STRUCTURAL ADDENDUM No. 1

Structural Framing Clarification

Project Name:	South Bruce Peninsula New Town Hall Conversion
Project Number:	2402330
Project Address:	370 William St., Wiarton, ON N0H 2T0
Date:	November 26, 2025

1 PROPOSED ROOF FRAMING PLAN
S2.4

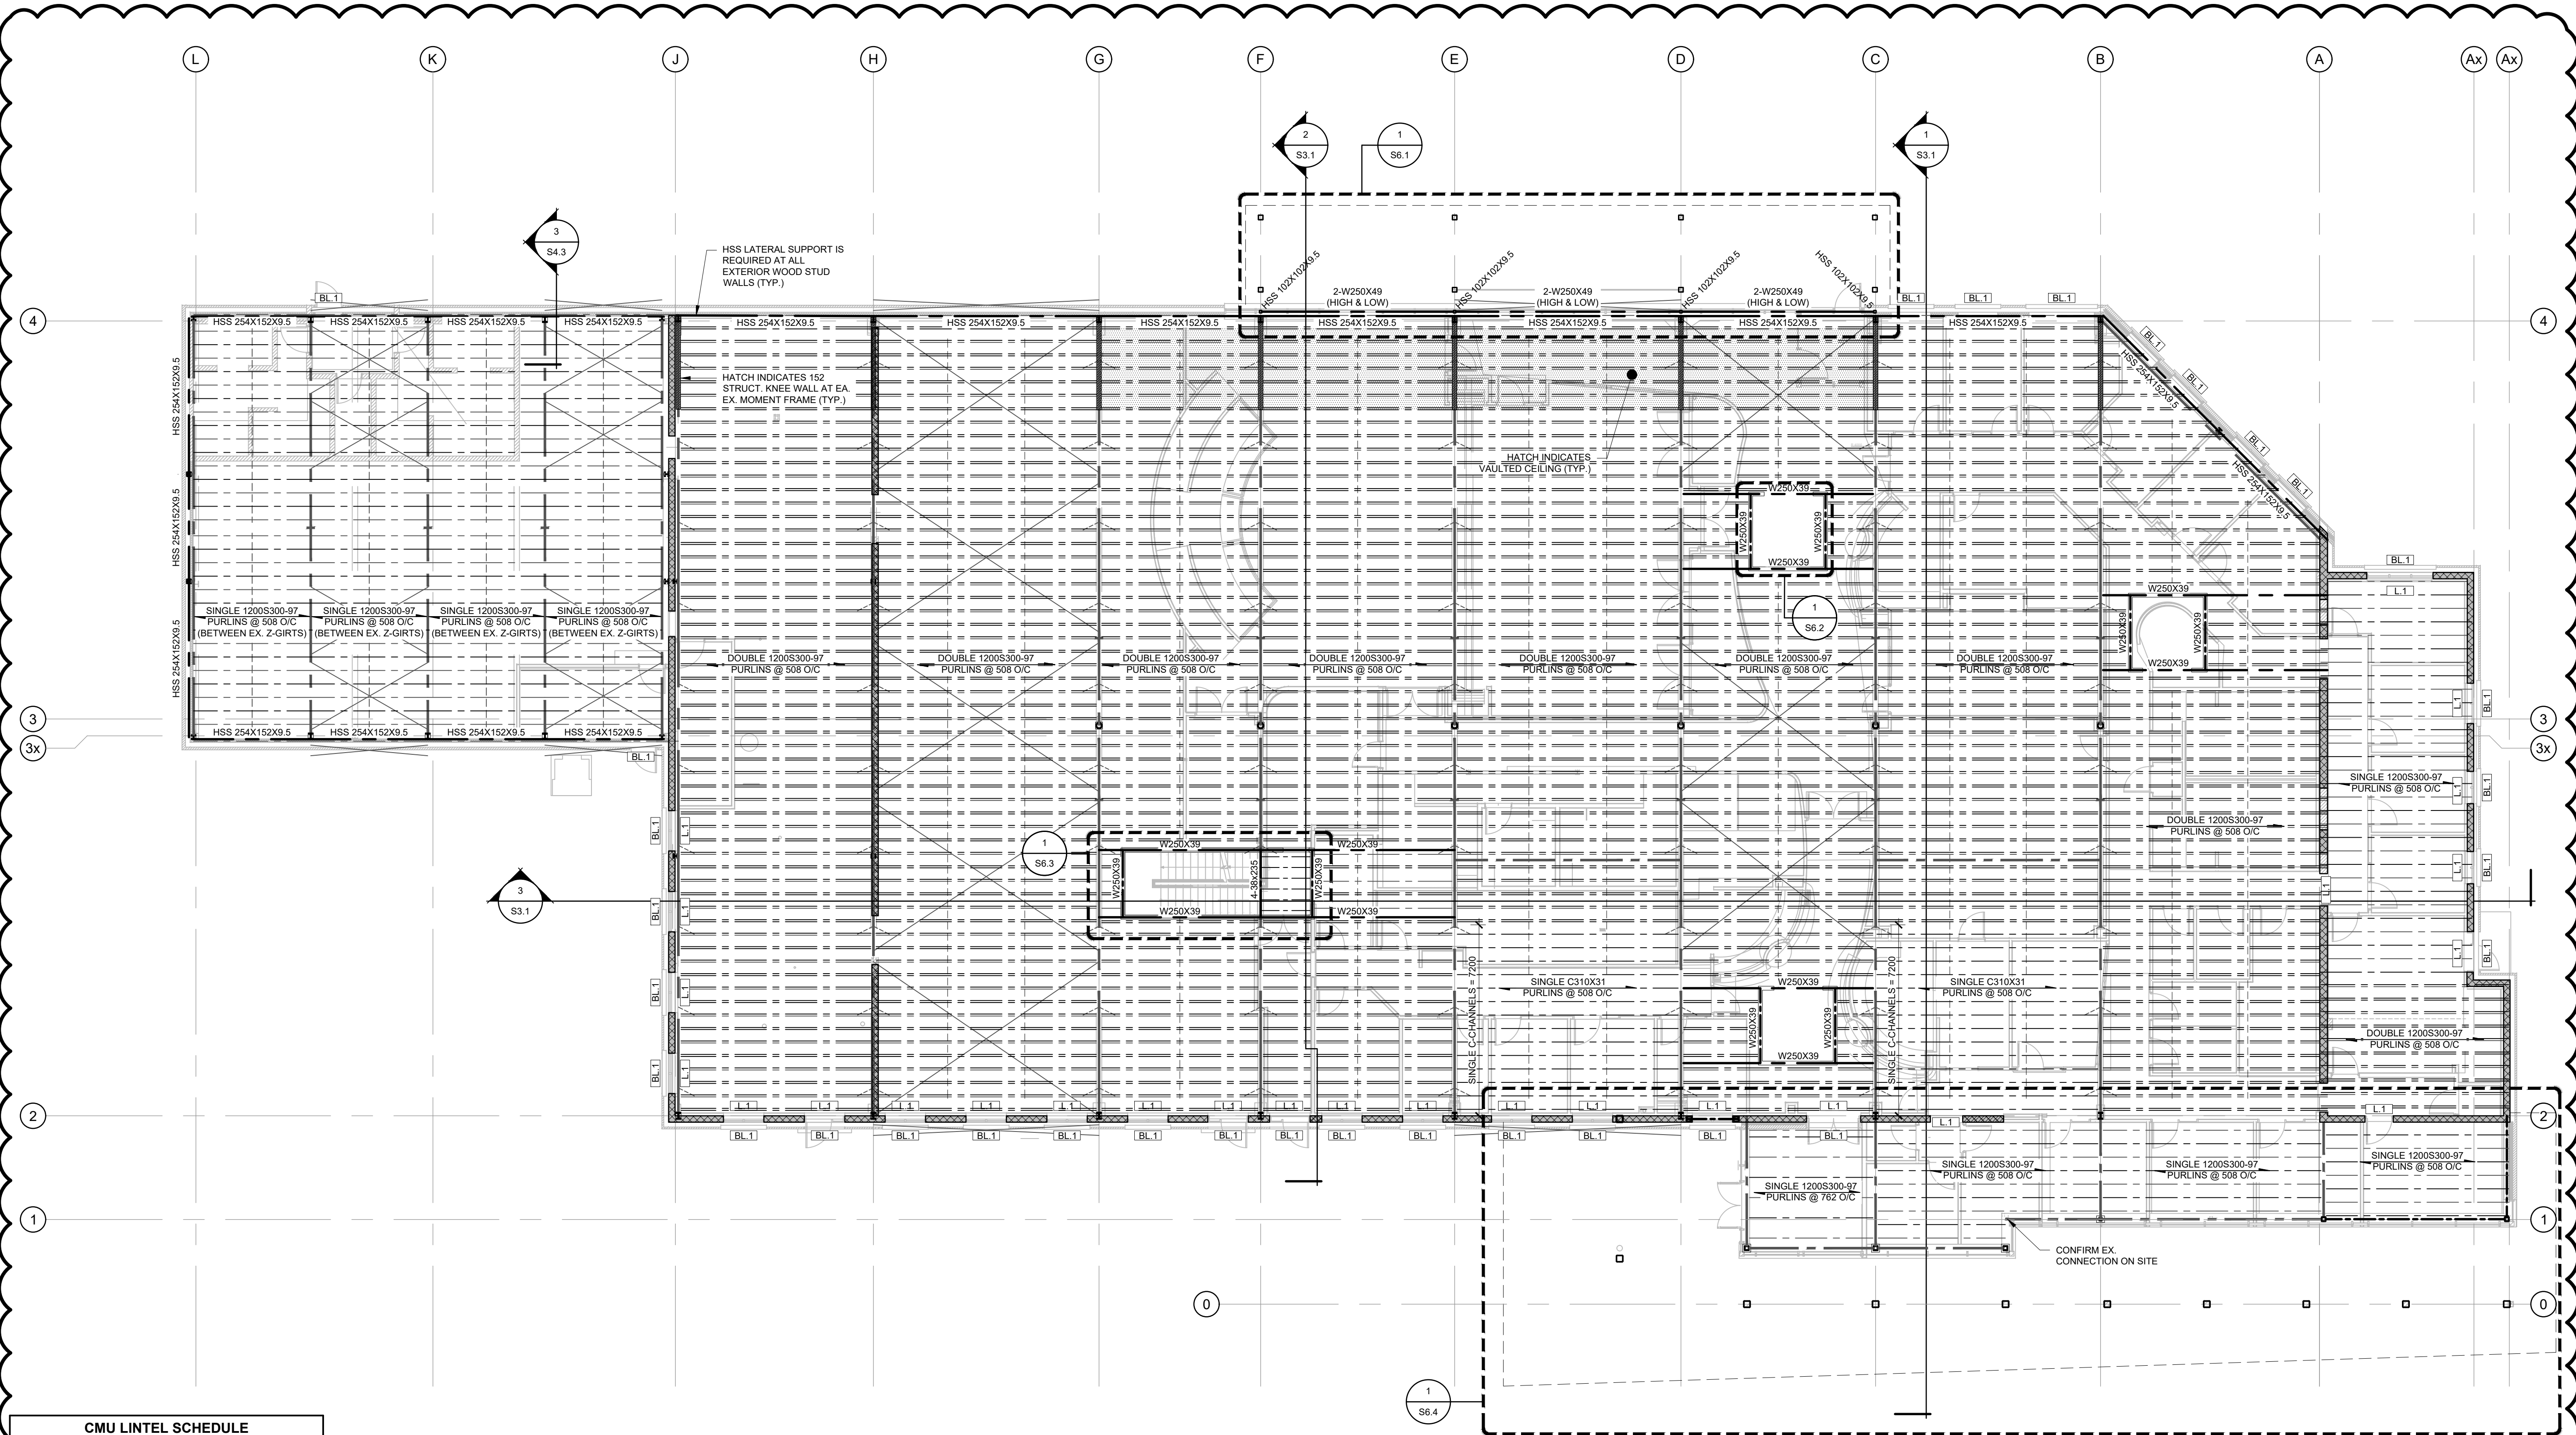
3. **S2.4 – Proposed Roof Framing Plan:**
 - a. Added wall section cutting through Grid Line 4 between K and J.
 - b. All roof purlin framing was revised to increase spacing for MEP (ref. plans)

- c. CMU lintel schedule was modified.
4. **S4.3 – Wall Sections:**
 - a. Added wall section cutting through Grid Line 4 between K and J.
5. **S5.1 – Section Details:**

REAR CANOPY STRUCTURE

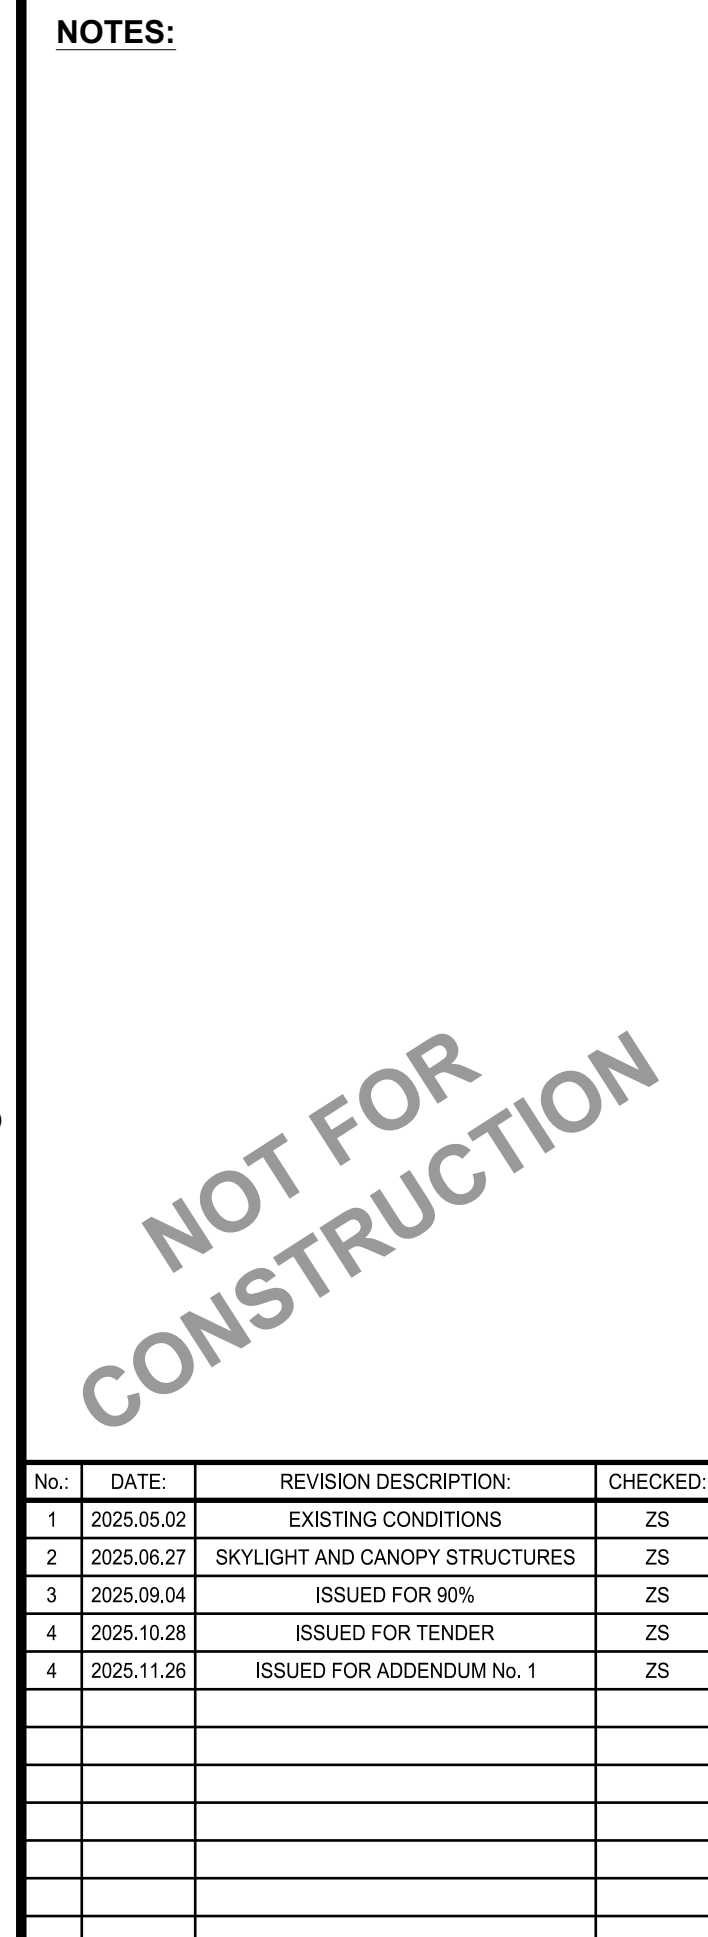
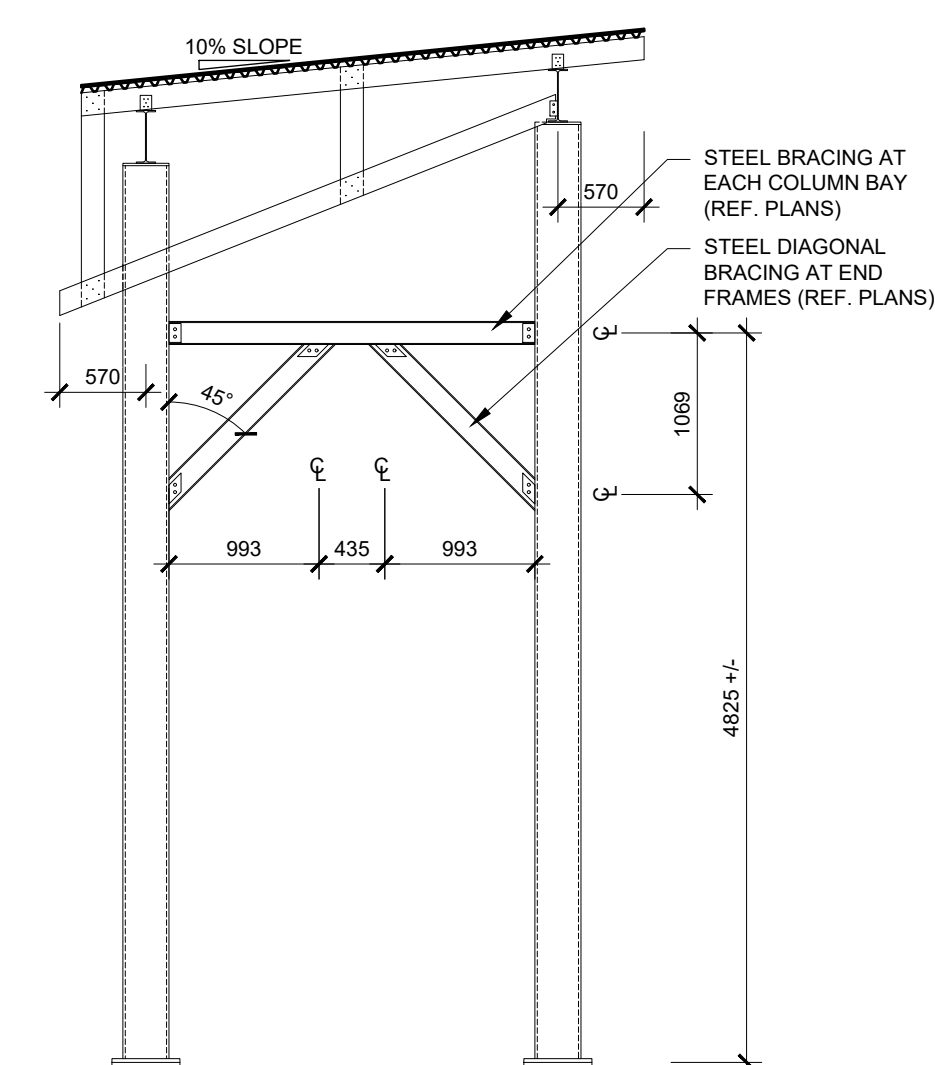
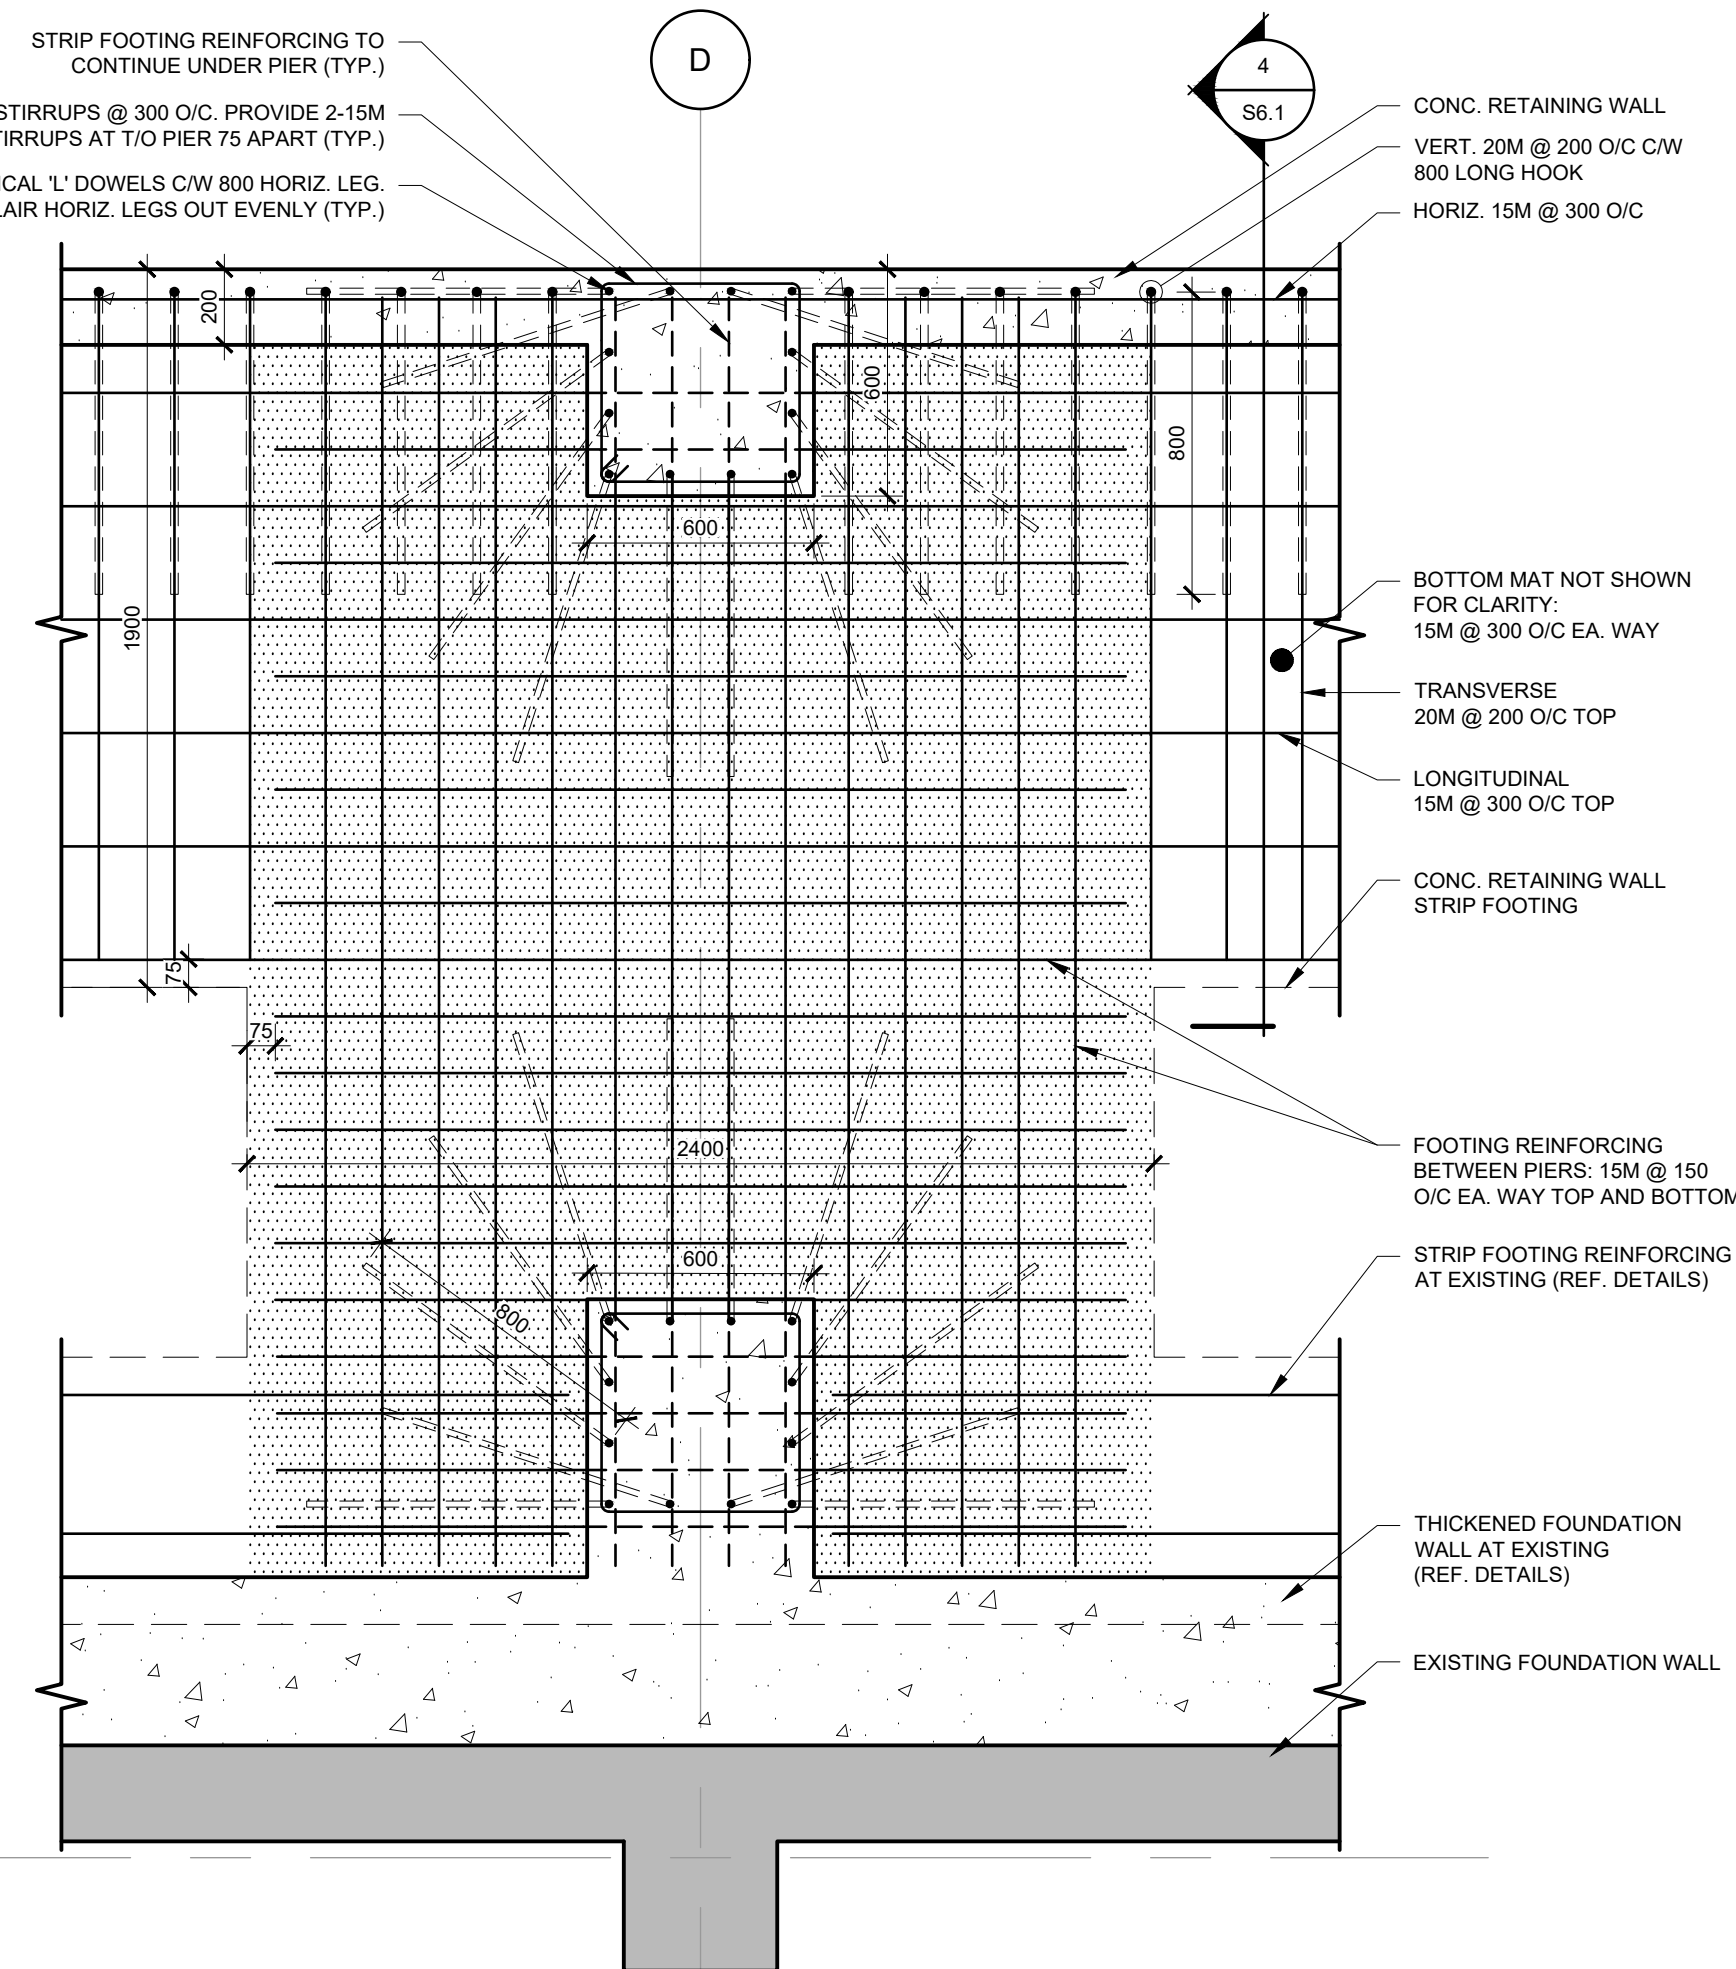
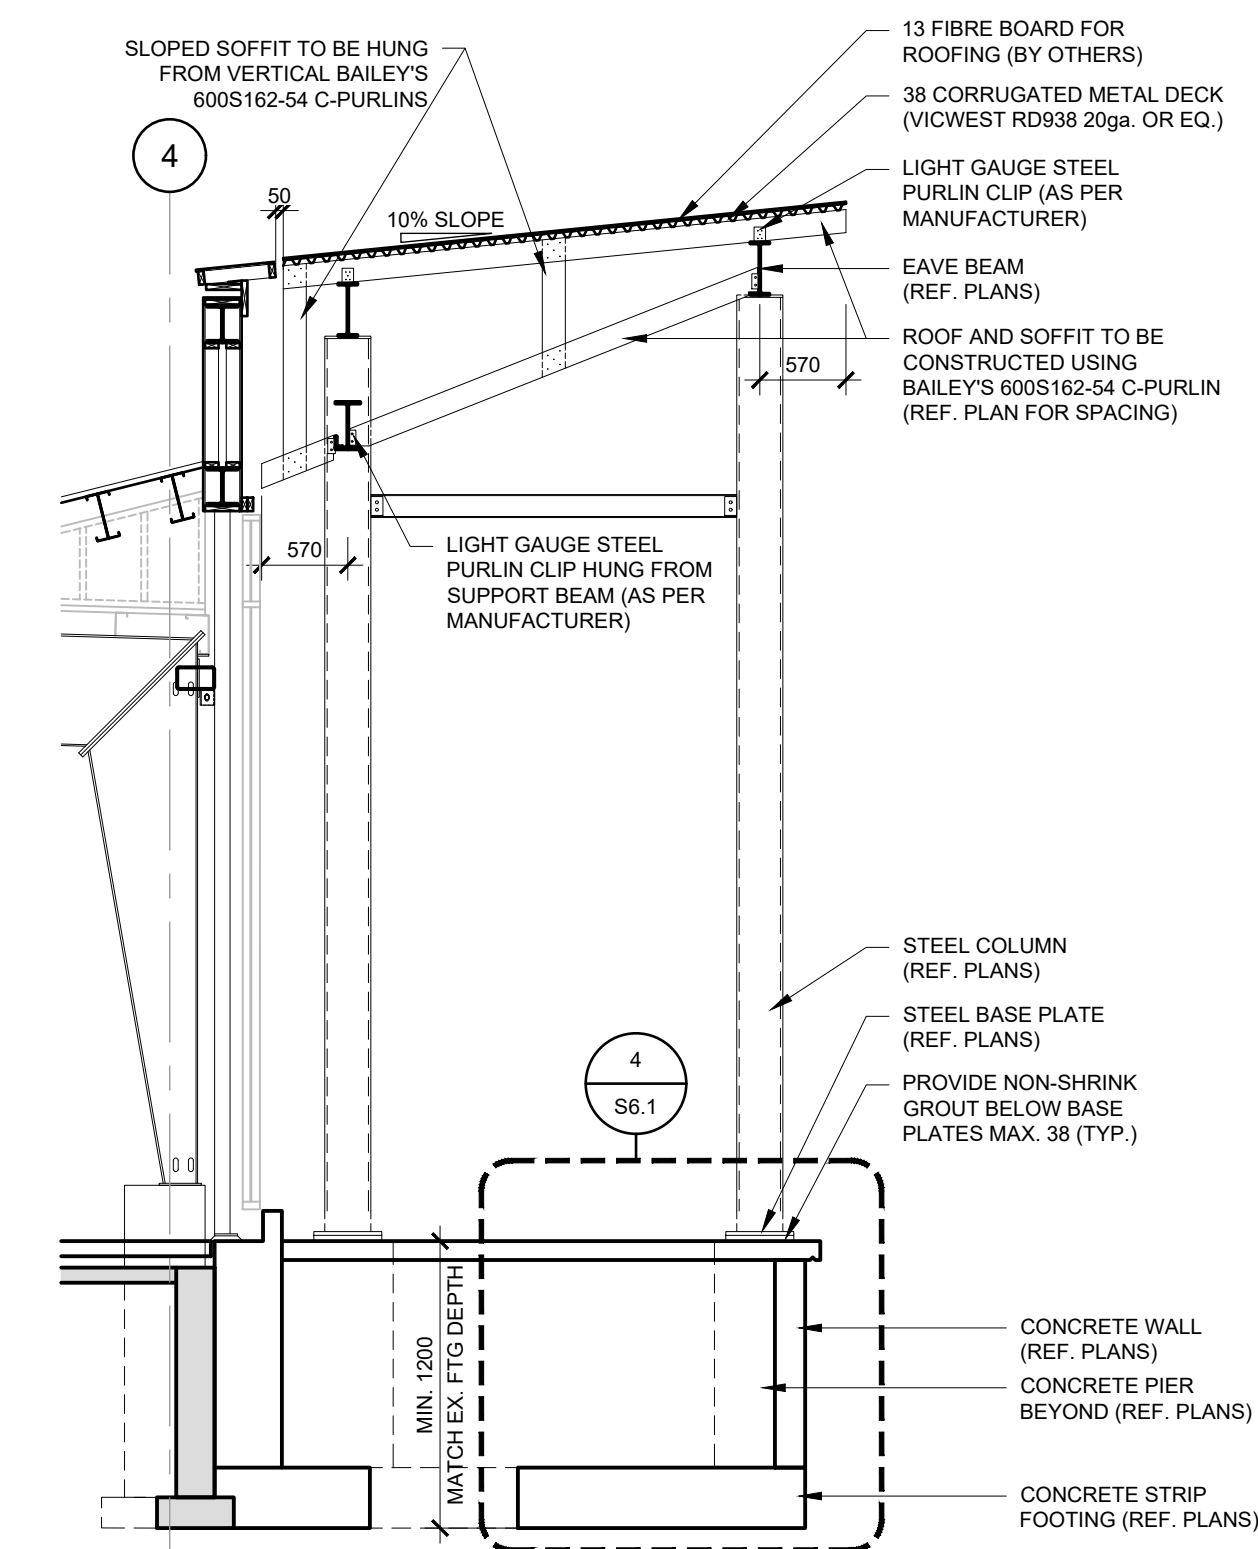
- e. 7/S5.2 – Added detail at existing moment frame base plate.
7. **S6.1 – Rear Canopy Structure:**
 - a. 4&5/S6.1 – Steel reinforcing in both the retaining wall and footings were revised. Base plates at exterior columns were raised, top of pier to be at same elevations as FFE.
